UNITED STATES PATENT AND TRADEMARK OFFICE

Office Action Summary

10/075,216

KOLOWSKI ET AL.

FIGURE 4

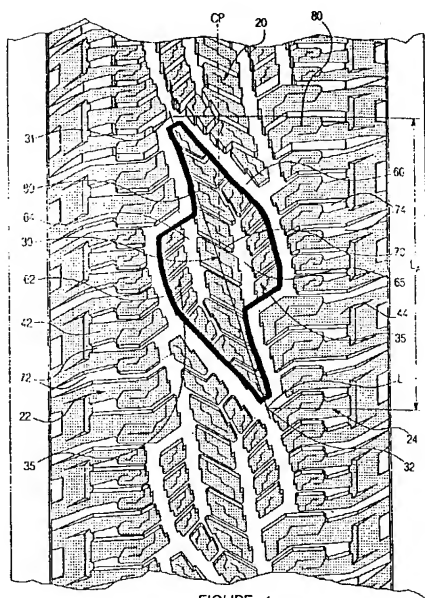
More importantly, the original disclosure fails to teach configuring the array such that it is an "S-shaped" / "substantially S-shaped". The original disclosure describes and illustrates three different arrays. Marked up copies of figures 4, 8, and 12 are provided below:

The markings were added by the examiner to facilitate understanding of the shape of the arrays as originally disclosed. As can be seen from each of figures 4, 8 and 12, none the illustrated arrays have a S-shape. With reference to figure 8, page 11 describes "elongated S shaped". However, this elongated S shape is for narrow groove 76 instead the shape of array 30.

FIGURE 4

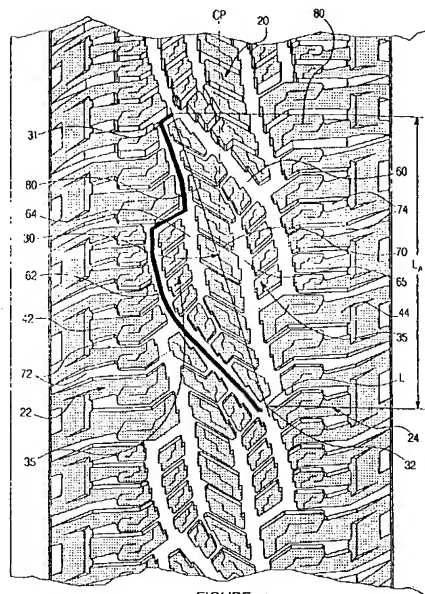
As to claim 15, the subject matter which was not described in the specification in such a way as to reasonably convey to one skilled in the relevant art that the inventor(s), at the time the application was filed, had possession of the claimed invention (i.e. the new matter) is the subject matter of the first and second boundary grooves being "substantially S-shaped" (this expression having no explicit basis in the original disclosure). Although the original disclosure describes groove 76 as being "S-shaped", it does not describe it as being "substantially" S-shaped. More importantly, groove 76 is a groove within an array instead of the boundary grooves defining the array. A marked up copy of figures 4, 8 and 12 is provided below:

The markings, which were added by the examiner, indicate the shape of a boundary groove. As can be seen from the marked up copies, none of the boundary grooves are "S-shaped" or "substantially S-shaped".
